**Remedial Investigation and  
Feasibility Study Work Plan  
Revision 2**

Nevada Environmental Response  
Trust Site; Henderson, Nevada

*Date:*  
**June 19, 2014**

**Surrounding Facilities**  
Nevada Environmental Response Trust Site, Henderson, Nevada

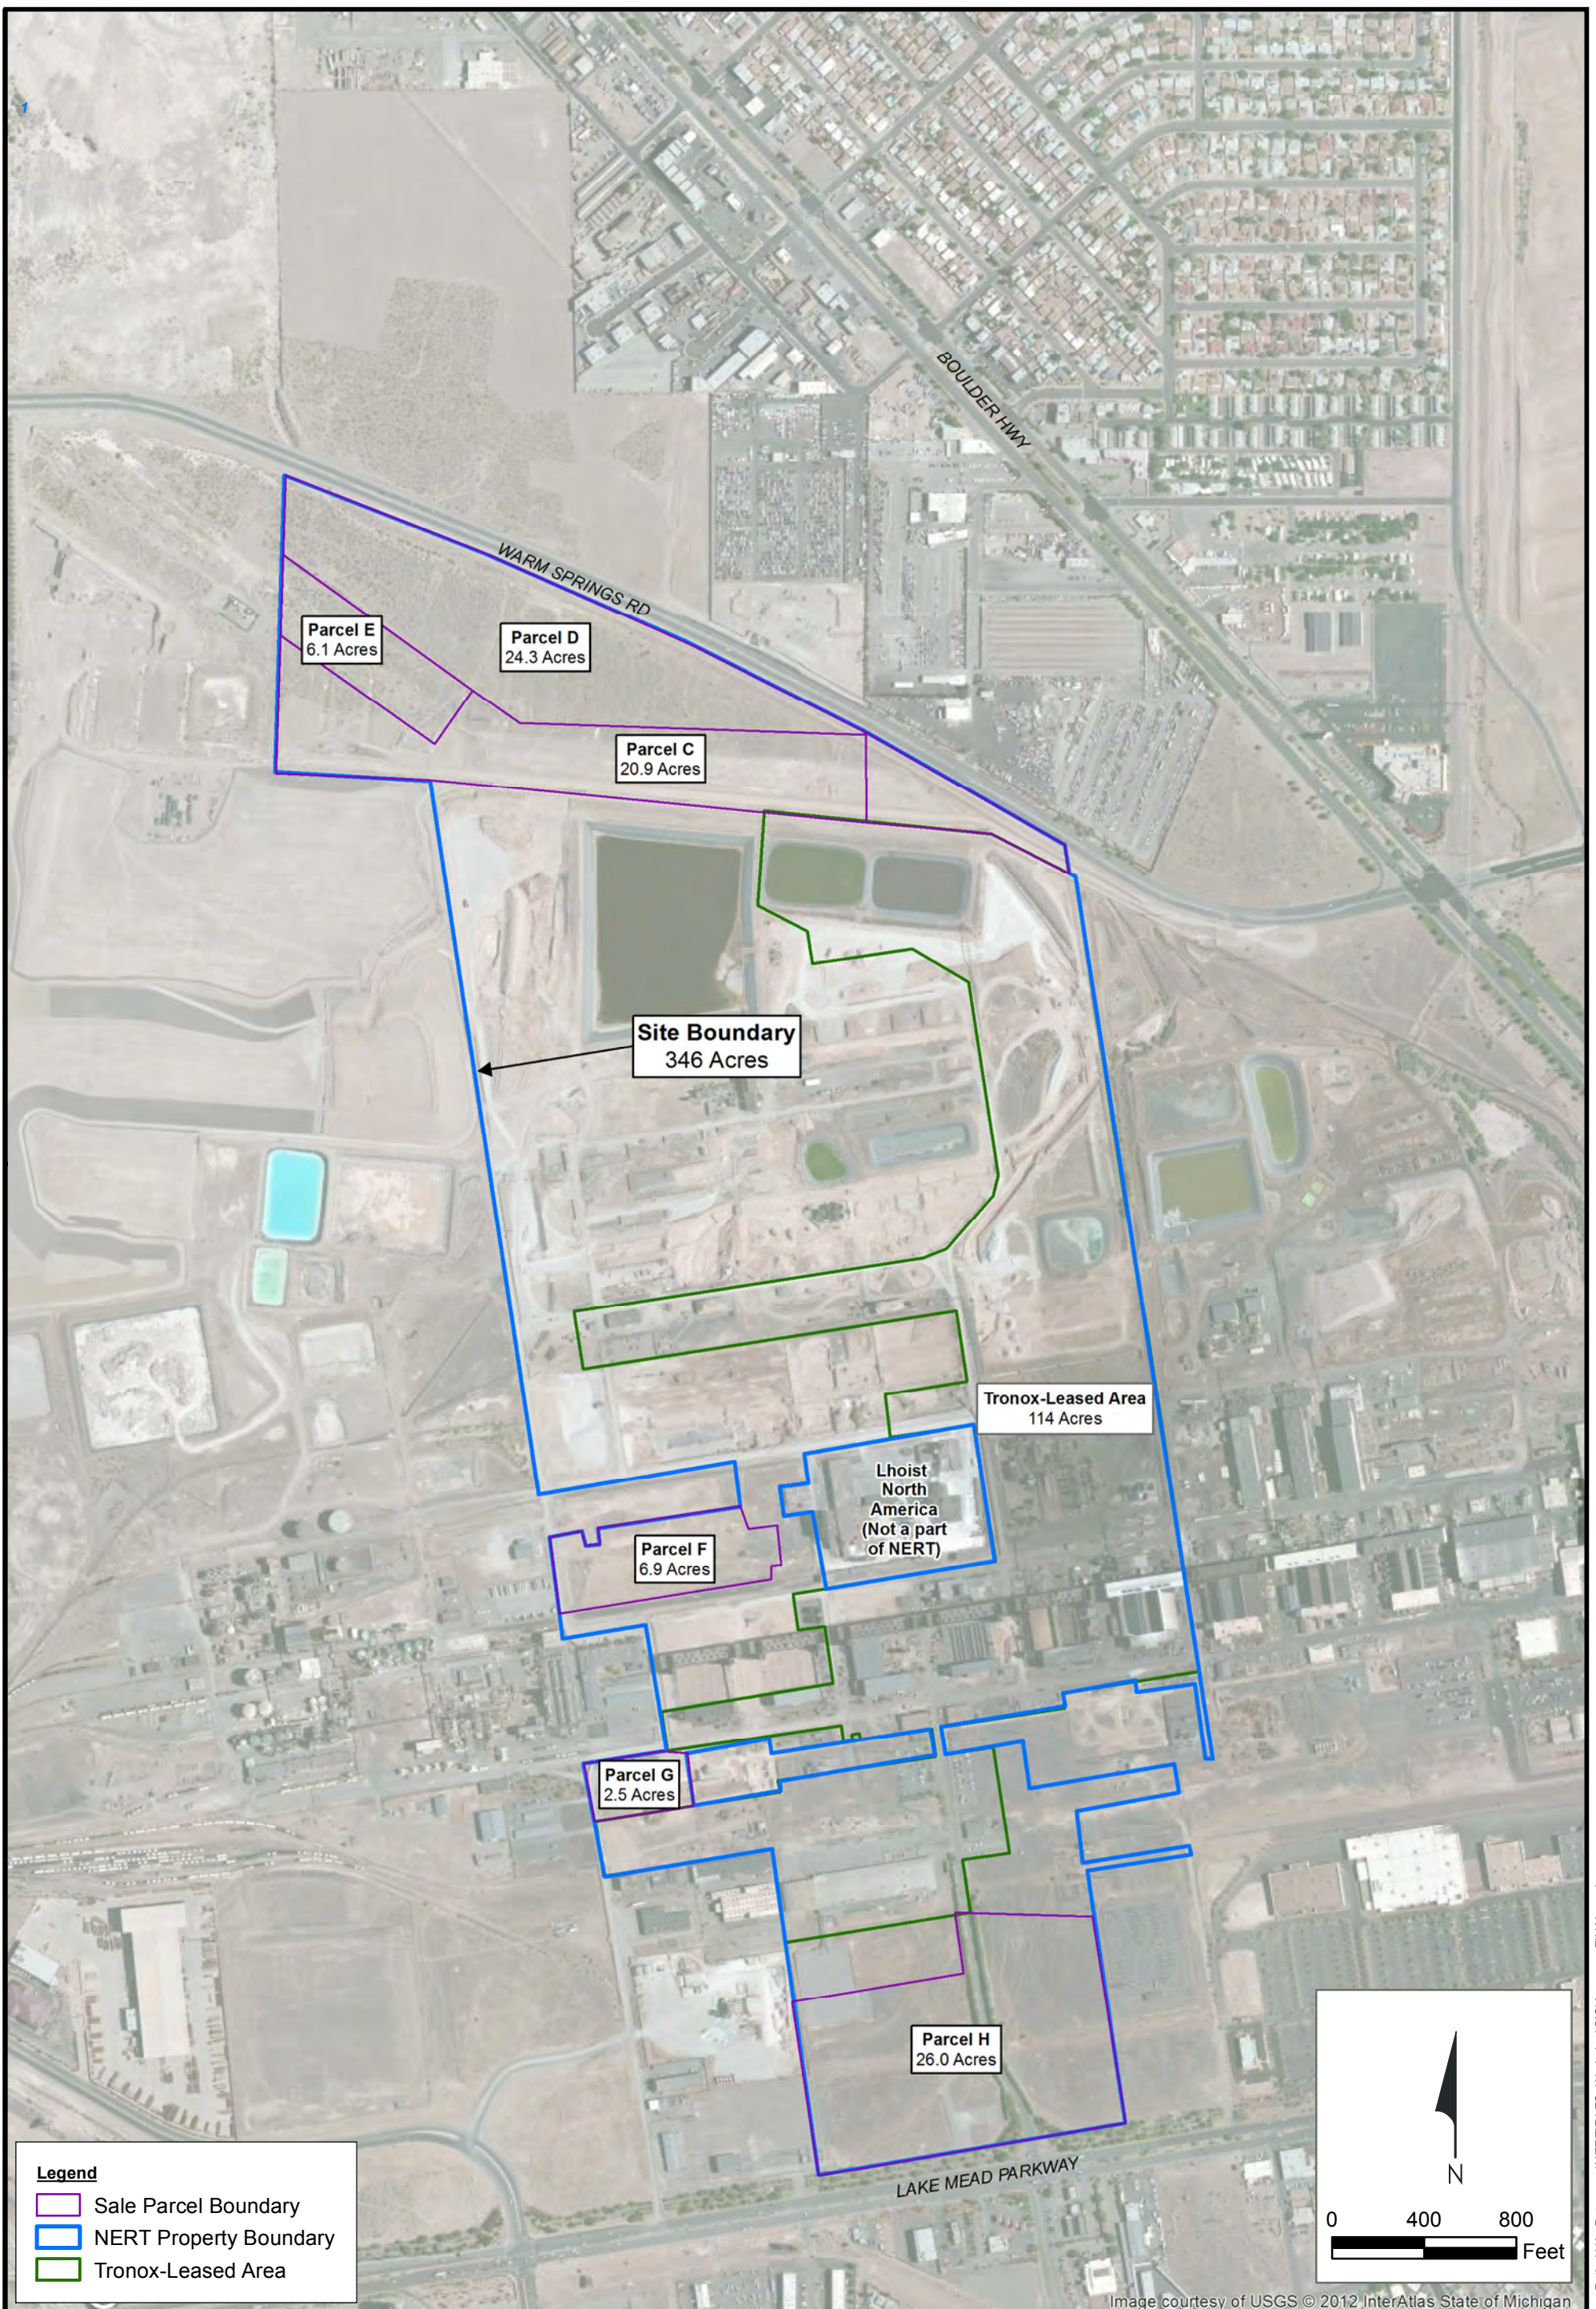
<p>71. Figure 2-1 Surrounding Facilities, please depict the BMI Dump per NDEP comments above.</p>	<p>The location of the BMI Dump will be added to Figure 2-1 of the revised RI/FS Work Plan.</p>
<p>72. Figure 4-1 Groundwater Extraction and Treatment System Flow Diagram, NDEP provides the following comments: The ferrous sulfate is added to the Lift Station 3 of AWF. Please clarify where the precipitates are removed for this influent stream and capacity of chromium removal with this method. The comment is also applied to the SWF.</p>	<p>The precipitates are retained in the activated carbon beds and are subsequently backwashed into the GW-11 pond using stabilized Lake Mead water. This practice has contributed to the solids loading of the GW-11 pond, which is discussed in response to Comment #20a. The overall efficacy of the carbon beds is also discussed in response to Comment #20b. The efficacy of the carbon beds, including the effect of the precipitates and the ultimate solids loading to the GW-11 pond, will be evaluated as part of the analysis of Remedial Action Alternatives to be included in the FS.</p>

**Well Field Extraction Rates and Chromium and Perchlorate Mass Removals**  
 Nevada Environmental Response Trust Site, Henderson, Nevada

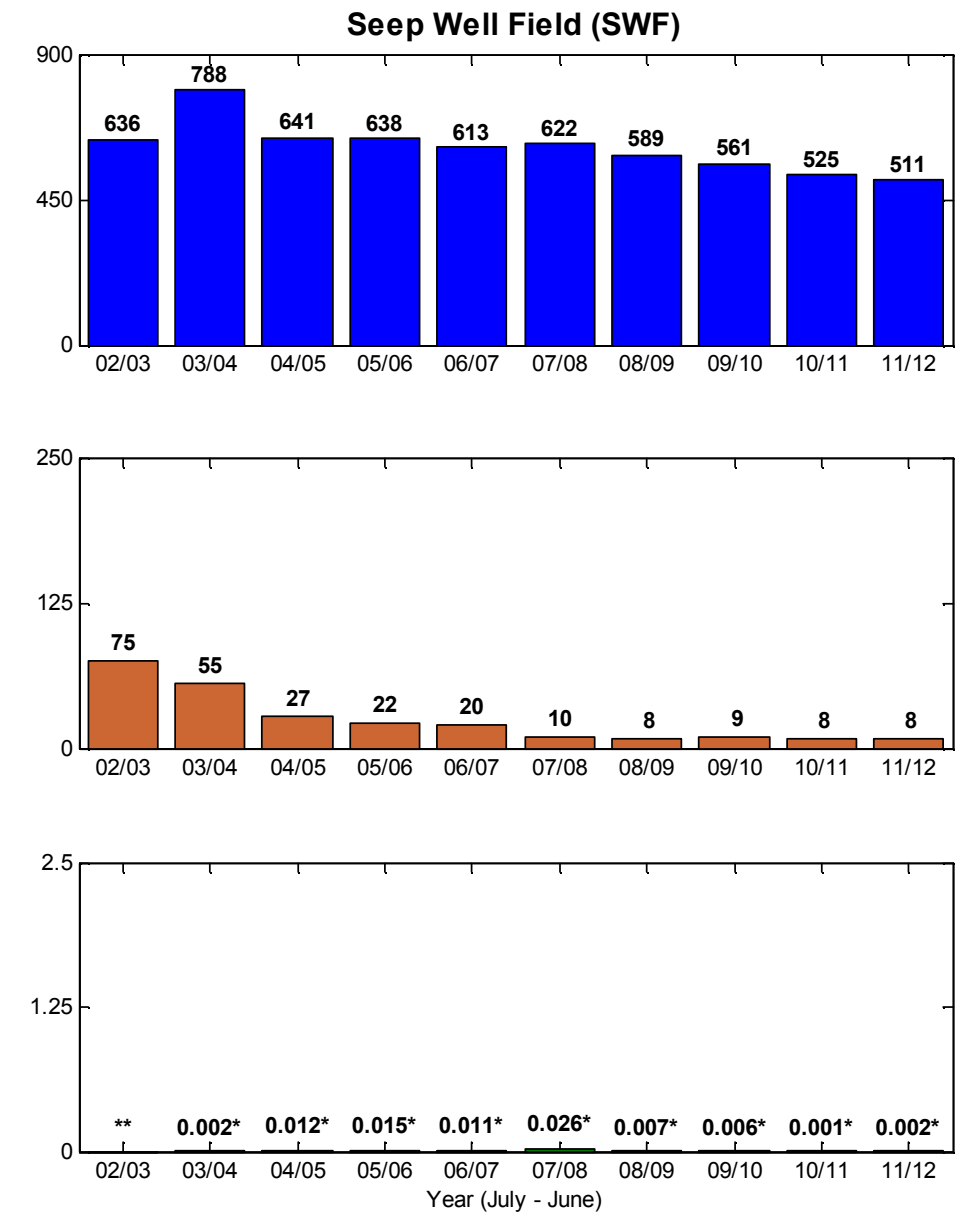
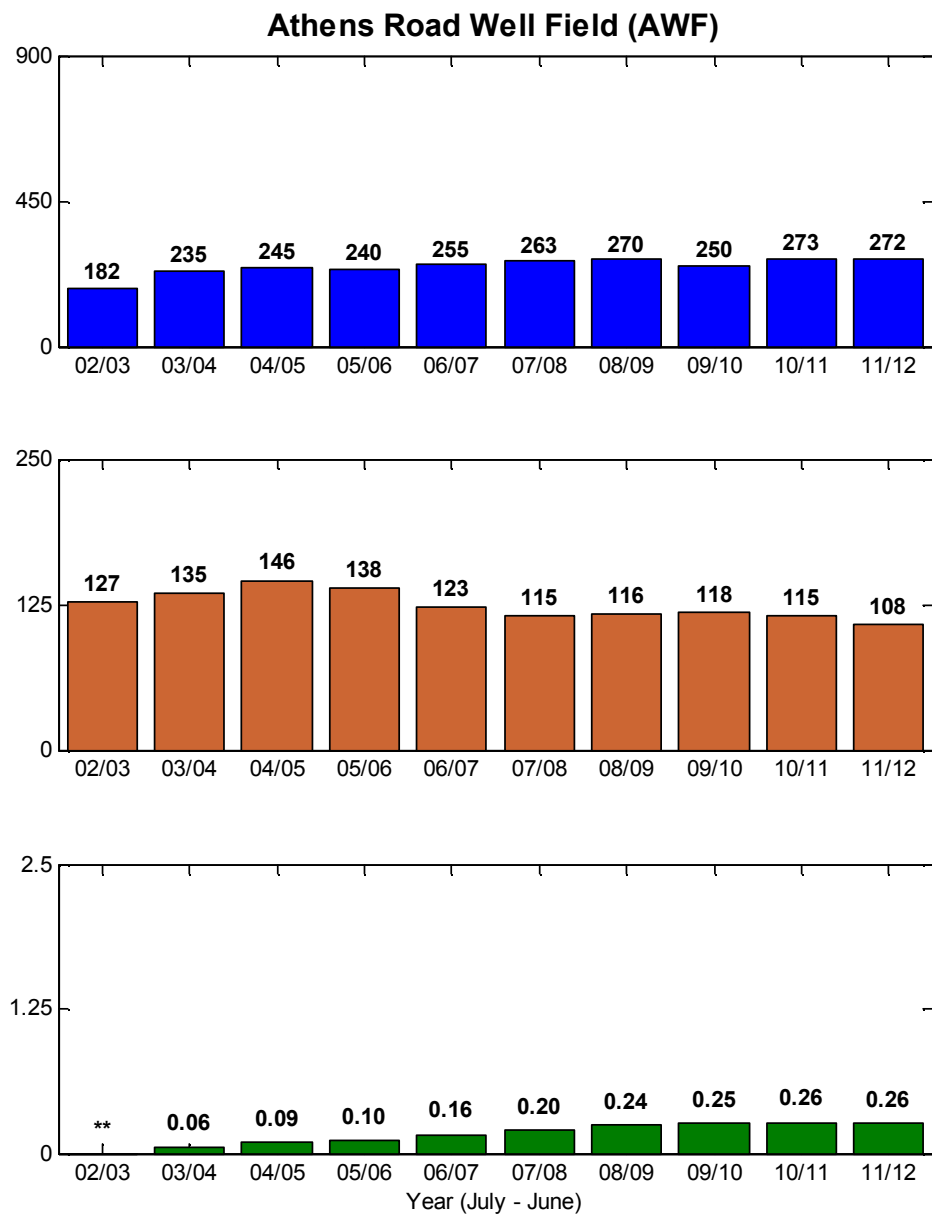
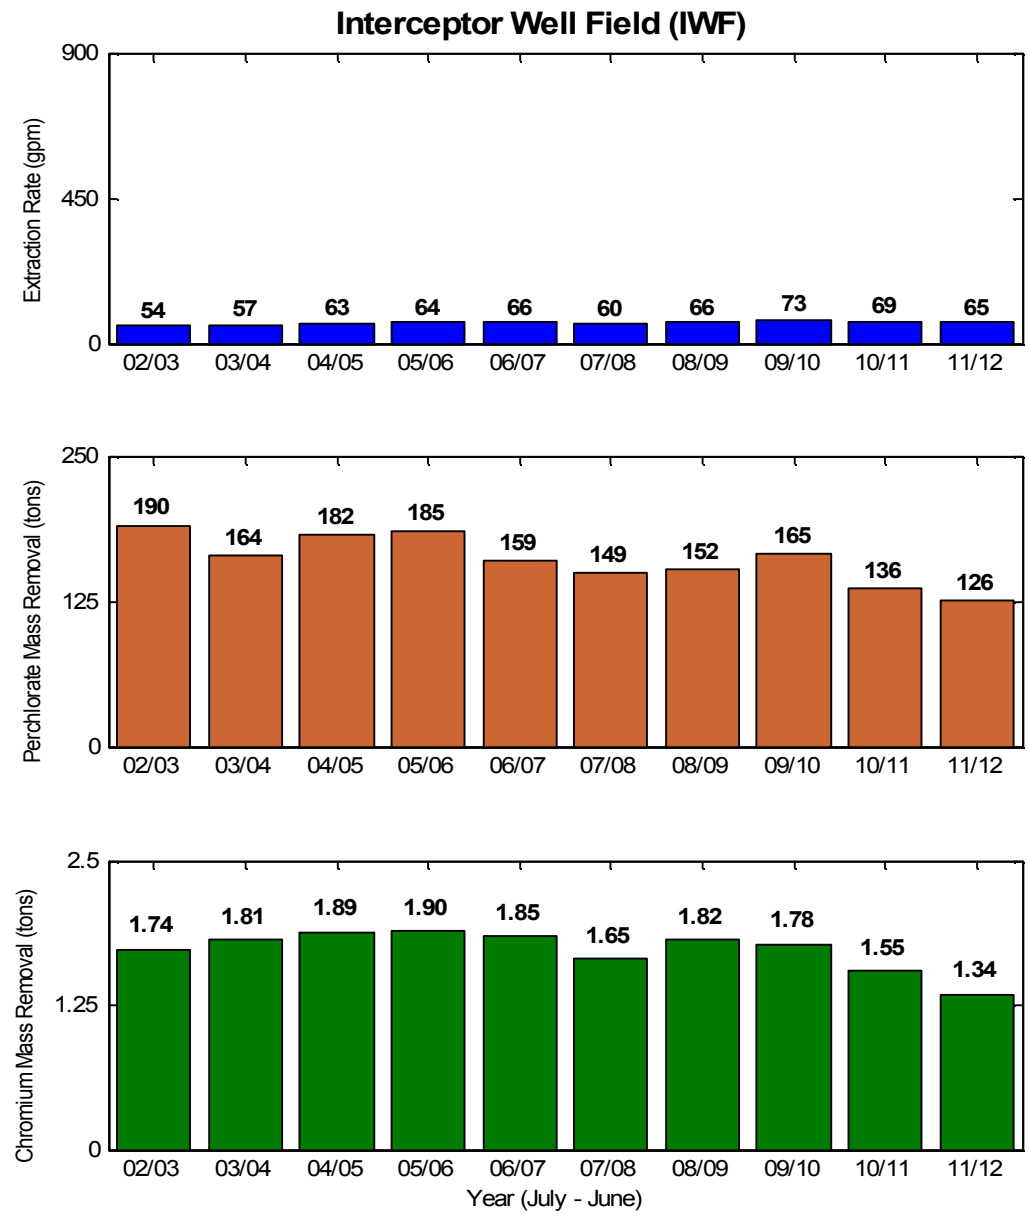
NDEP Comment	Response
73. Figure 4-5 Well Field Extraction Rates and chromium and Perchlorate Mass Removals, the total Chromium removed from the AWF has slightly increased consistently with time; however, perchlorate has not. Please discuss in the text of the revised Deliverable.	A discussion of the chromium and perchlorate mass removed from the AWF over time will be added to the text of the revised RI/FS Work Plan.

**Conceptual Site Model Diagram: Facility Area and Downgradient Plume**  
 Nevada Environmental Response Trust Site, Henderson, Nevada

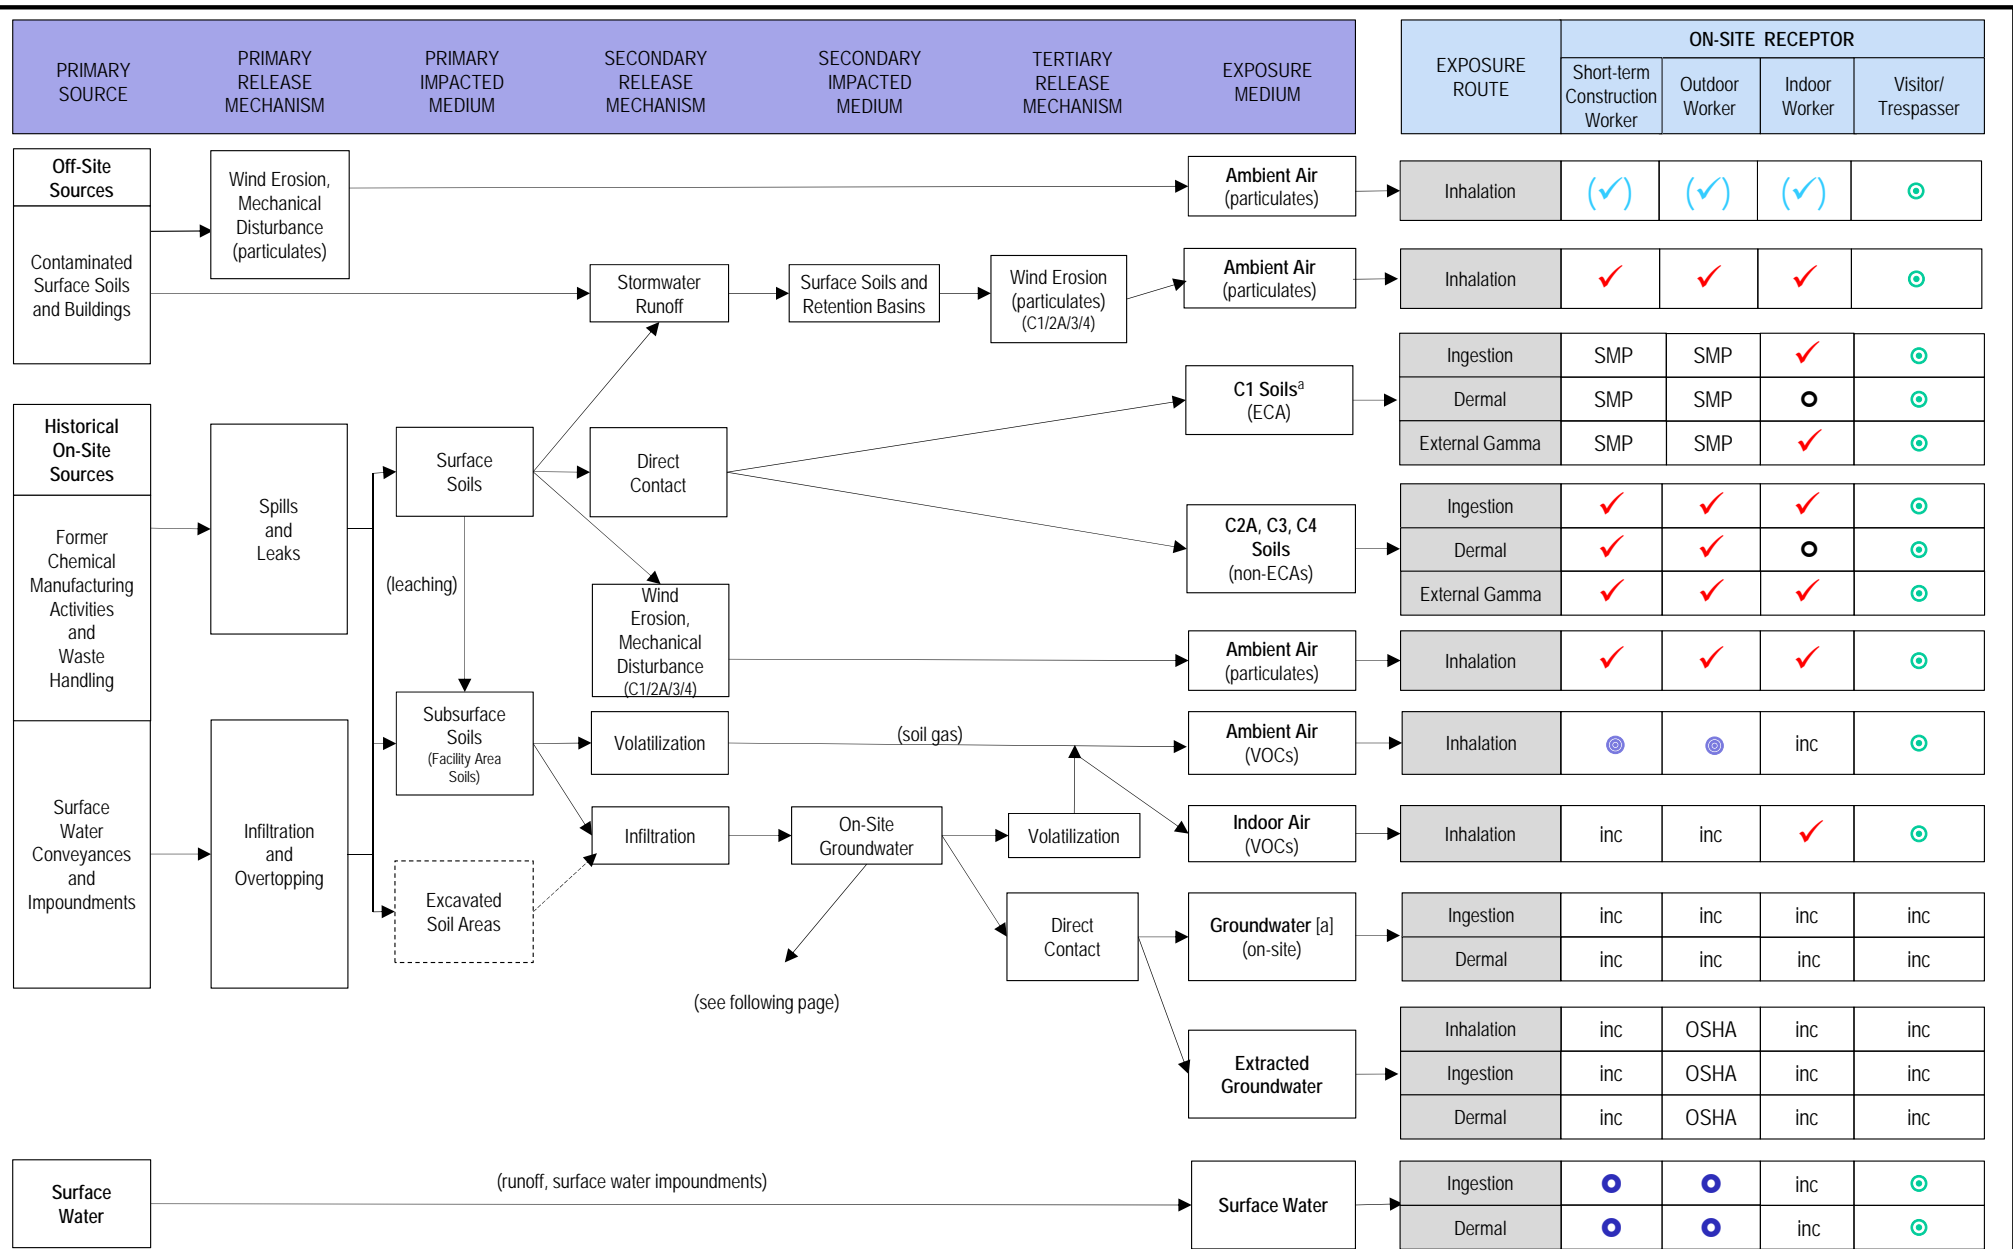
74. Figure 5-1 Preliminary Conceptual Site Model Diagram: Site and Downgradient Plume, the figure does not include ecological receptors; please refer to Figure 5-4, which indicates both terrestrial and aquatic receptors.	See response to Comment #6.
